Serial: RNP-RA/02-0036

H. B. ROBINSON STEAM ELECTRIC PLANT, UNIT NO. 2  
DOCKET NO. 50-261/LICENSE NO. DPR-23

**RESPONSE TO NRC REQUEST FOR ADDITIONAL INFORMATION  
FOR THE FOURTH TEN-YEAR INTERVAL INSERVICE INSPECTION PROGRAM**

PROFESSIONAL ENGINEER:  
 QUALITY LEVEL:  
**SAFETY RELATED**  
 CAROLINA POWER & LIGHT COMPANY  
 NUCLEAR ENGINEERING DEPARTMENT  
 PLANT: ROBINSON PLANT - UNIT 2  
 TITLE: REACTOR VESSEL SHELL WELDS  
 SCALE: NONE

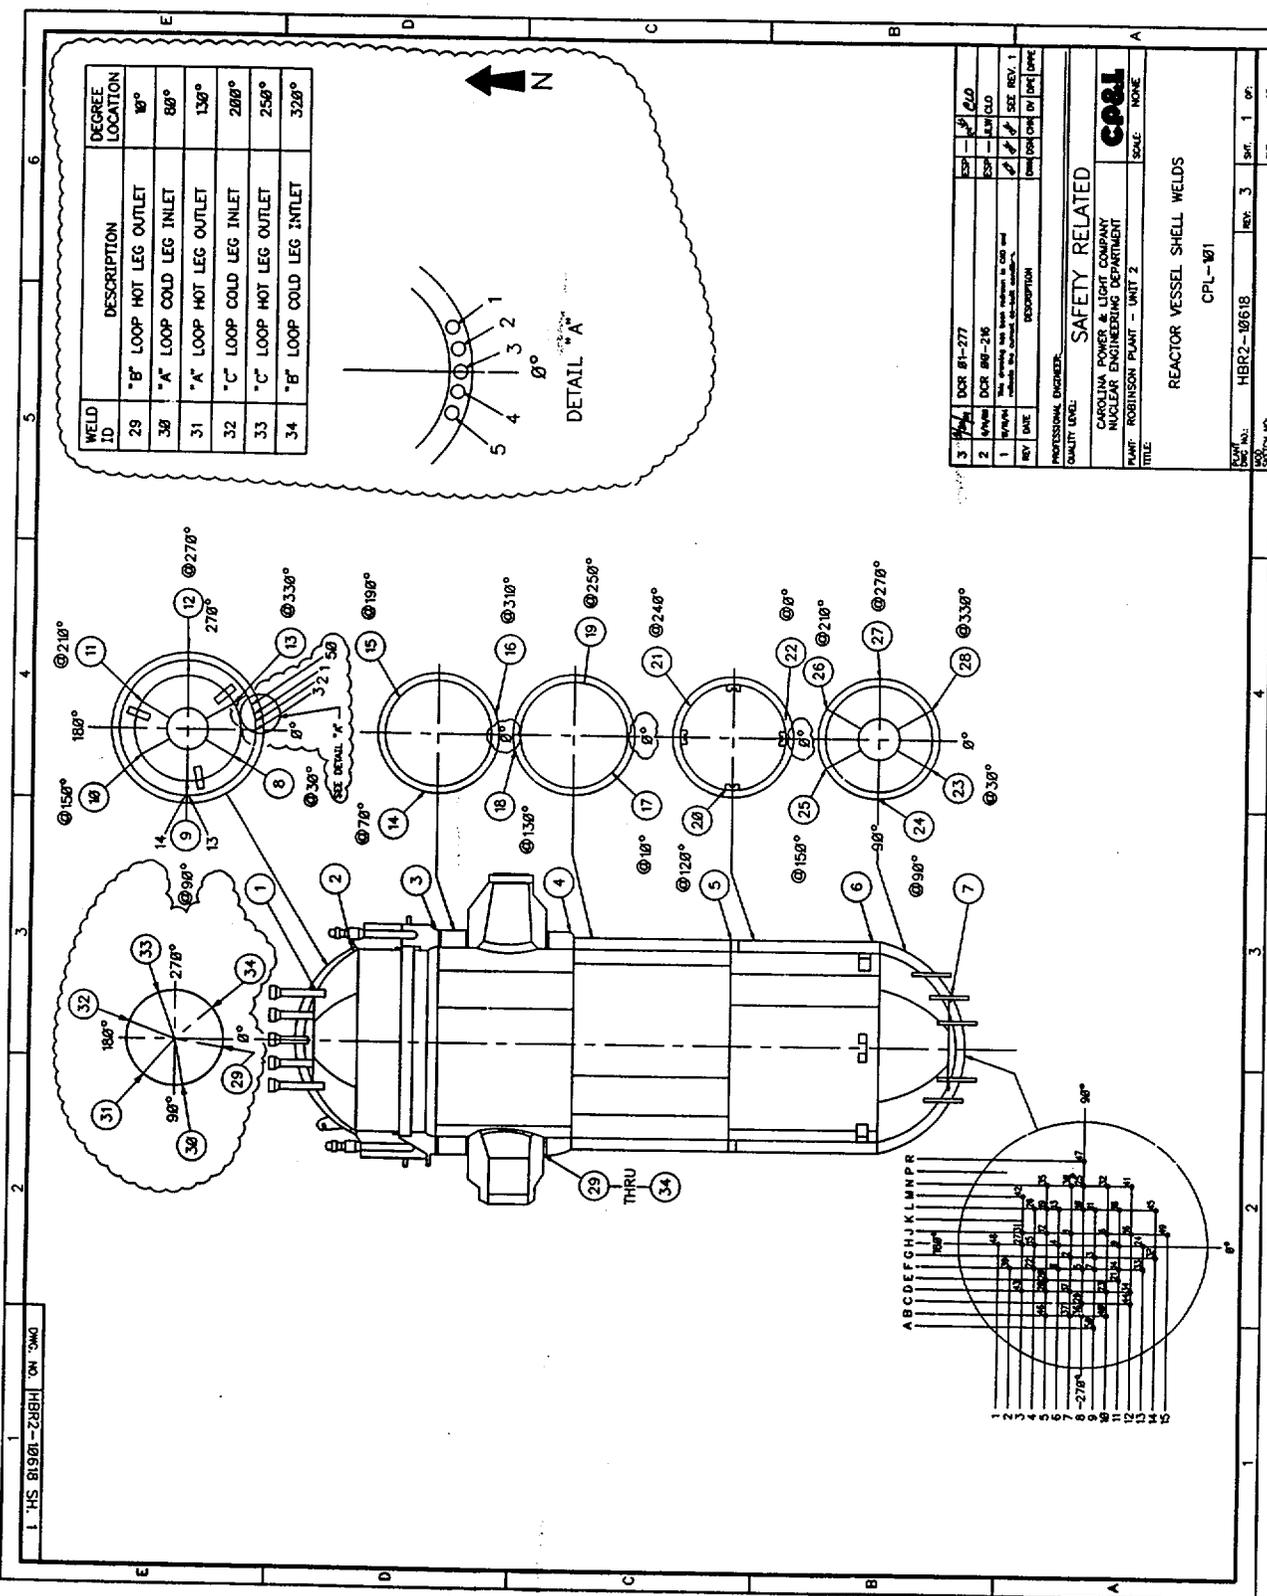
Pursuant to 10 CFR 50.55a(g)(5), the licensee requested relief from the Code-required volumetric examination of the reactor pressure vessel closure head peel segment-to-disk circumferential weld. In order for the proposed relief to be evaluated, please provide the following:

Accessibility for examination of this weld was not provided in the original plant design, which occurred prior to issuance of the Section XI ISI examination requirements. The closure head peel segment-to-disk weld is completely enclosed within the pattern of Control Rod Drive Mechanism (CRDM) penetrations inside the reactor vessel shroud, such that no portion of the weld is accessible for either surface or volumetric examination. Please provide sketches or photos showing the inaccessibility of the subject weld.

Relief was requested for the closure head peel segment-to-disk weld (weld # 1) that is completely enclosed within the pattern of Control Rod Drive Mechanism (CRDM) penetrations inside the reactor vessel shroud. The drawing (HBR2-10618/Sheet 1) provided in Attachment III shows additional details regarding the impracticality of this volumetric examination.
